CITY OF HOUSTON
FINANCE DEPARTMENT
Strategic Procurement Division

Subject: Letter of Clarification No. 2: - S63-C25711: Concrete Panel Replacement for City Streets for the Department of Public Works and Engineering

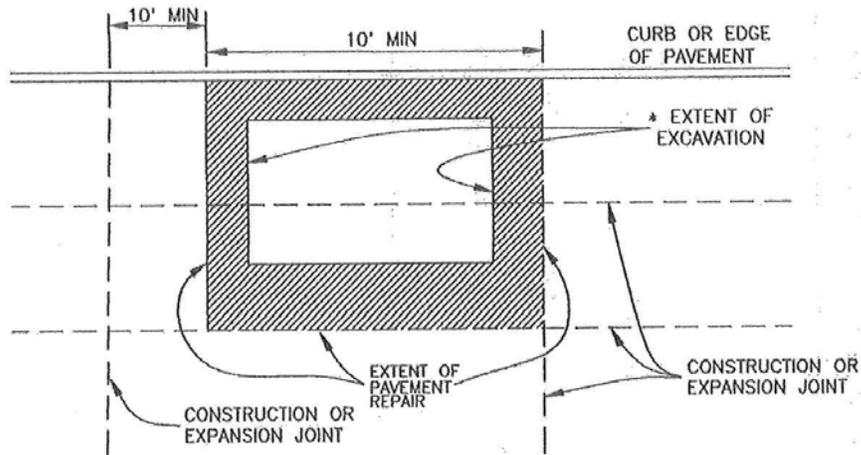
Question No. 1: "The attached two sheets (Exhibit "A") are representing the requirement of the City of Houston, Department of Public Works and Engineering for the concrete pavement restoration for street paving based on the age of the pavement. Please confirm if the information on these sheets apply to this project."

Answer: Yes, the information on the two sheets provided will apply to this project and or contract.
